# Portage Bay Park

## Project Description

## Meeting Summary

This was the Seattle Design Commission's (SDC) review of the project at schematic (60%) design. At the meeting, the SDC voted 5-1 to approve the Portage Bay schematic design with recommendations.

Figure 4: Proposed shade pavilion

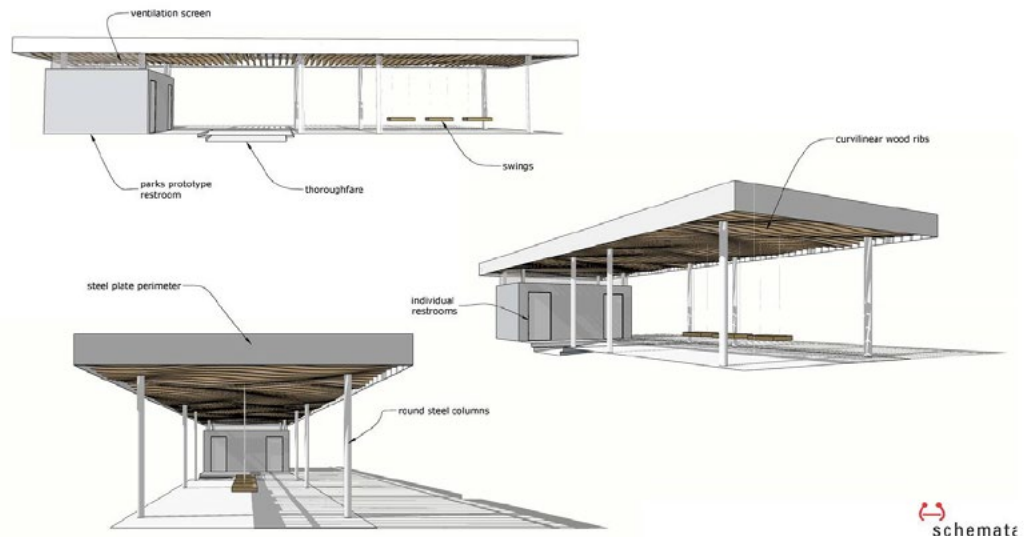
Overall, the SDC provided positive feedback regarding the covered pavilion. Specifically, Commissioners appreciated the detailed ribs as it related to a portion of the site and its maritime history. The Commission had some disagreement on how the orientation of the rib detailing would work best visually - whether the slats would be better oriented so the wave effect is visible from the street or so the waves are only seen as a second read from within the pavilion - as well as how the ribs will create or affect shading. There was discussion and some disagreement about the proposed color and width of the structures' fascia. Commissioners recommended the design team provide alternative renderings of the pavilion in order to build their case as to why this is the best detailing for this specific element. The SDC encouraged the design team to continue exploring the programming underneath the pavilion, including how the inclusion of attached swings will affect use and circulation in contrast with the inclusion of moveable tables and chairs. Commissioners thought that the pier was working very nicely. There was concern that the quantity and type of seating might not be adequate, especially along ADA routes through the park.

1. Further define programming along the street edge and understand the parks connection with the surrounding context
2. Consider incorporating interpretive elements throughout the project site, including a portage trail or in water features
3. Consider providing additional seating underneath the pavilion and throughout the park
4. Develop the pavilion roof so that it achieves a strong aesthetic presence from multiple points of view, adequate shade cover, efficiency of costs, and ease of maintenance.
5. Continue to study how the wood detailing under the pavilion's roof can be viewed from different locations to maximize it's intended effect.
6. Develop a grading plan and topographic sections to better understand the relationship between Boat Street and the waterfront.
7. Study the proposed location of swings in the pavilion
